P-6831-2 S1897 29127

NAME	DATE
(JINDAL)	JINDAL ALUMINIUM LTD.	DRAWN	RAGHAVENDR	14-06-2007
CVALDOL OF CHALITY	BANGALORE-560073 (INDIA)	CHECKED		
SYMBOL OF QUALITY AN ISO 9002 COMPANY		APPROVED		
ALL DIMENSIONS ARE IN mm. ROUND OFF ALL SHARP CORNERS WITH 0.40 mm. TOLERANCES WILL BE AS PER DIN 17615 UNLESS OTHERWISE SPECIFIED		SCALE		1:1
		AREA mm ²		2706.633
		PERIMETER mm.		210.465
PARTY'S NAME	BRITISH ENGINES INDIA (P) LTD., BANGALORE	WEIGHT kg/	/m	7.308
		DRAWING	No. SE	ECTION No.
PARTY'S DRAWING No.	AS PER SPECIFICATION	P-6831-2 -		-
	0000 T0	S1897 S189		97-ISSUE-2
ALLOY & TEMPER	6082 T6	29127 2912		27
DESCRIPTION	HEXAGONAL TUBE

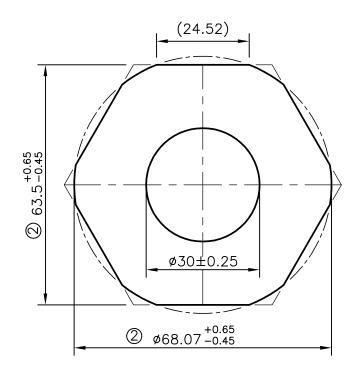
ISSUE - ② TOLERANCE CHANGED FROM 68.07 ± 0.45 TO $\phi68.07^{+0.65}_{-0.45}$ AND 63.5 ± 0.45 TO $63.5^{+0.65}_{-0.45}$ AND OUTER SHAPE ALSO CHANGED AS PER CUSTOMER REQUIRMENT
